Detailed Site Plan 9113 Baltimore Avenue

DSP-22015

SUBJECT: Detailed Site Plan DSP-22015
9113 Baltimore Avenue

The Urban Design Section has reviewed the detailed site plan for the subject property and recommends APPROVAL with conditions, as described in the Recommendation section of this technical staff report.

Figure 6: Wall sign located on the northwest corner of building

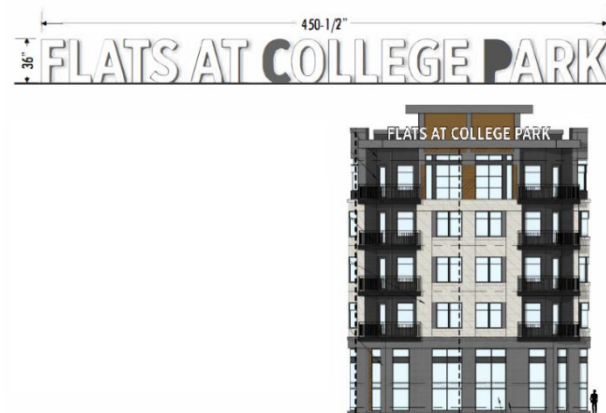
The applicant proposes multiple building-mounted signs: one back-lit, channel-letter, building-mounted marquee sign will be located on a projecting metal canopy at the northwest corner of the building, facing the intersection of US 1 and Delaware Street, as shown in Figure 6. Another vertical, back-lit, sign will be mounted on the western building façade that will be visible from US 1, as shown in Figure 7. Other building-mounted, back-lit, channel-letter signs are proposed along US 1 and Cherokee Street, above the residential, commercial, and parking garage entrances. No sign is proposed for a residential entrance located off Delaware Street. In addition, no sign is proposed at the southwest corner of the building, to identify it for travelers coming up US 1. Additional signs should be provided at both of these locations. The submitted sign details for the project includes the square footage for each sign, but not all the details required to fully evaluate conformance with the sign requirements of the D-D-O Zone (page 254 of the sector plan). The maximum gross area of signs, on a given façade, shall not exceed 10 percent of the façade area of the commercial portion of the building, though architectural signs or signage painted on a building façade or mounted on the roof may exceed this limit, in certain cases. A condition has been included requiring the applicant to demonstrate conformance with the applicable sign requirements.

Figure 9: Building Form exhibit from the Sector Plan

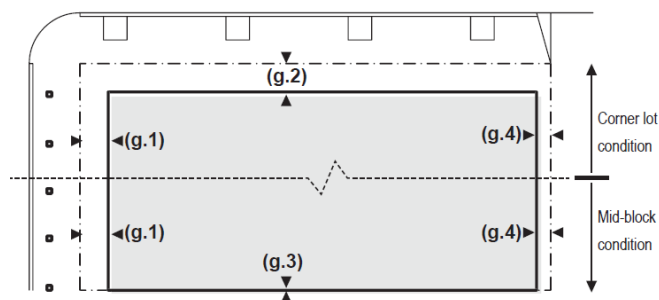
Along Delaware Street, the building is set back between 11.5 feet and 15.6 feet from the right-of-way line. Along Cherokee Street, the building is set back between 11.9 feet and 29.6 feet from the right-of-way line. The applicant is requesting an amendment of 3.6 feet for the build-to line requirement along Delaware Street and 17.6 feet to the setback requirement along Cherokee Street.
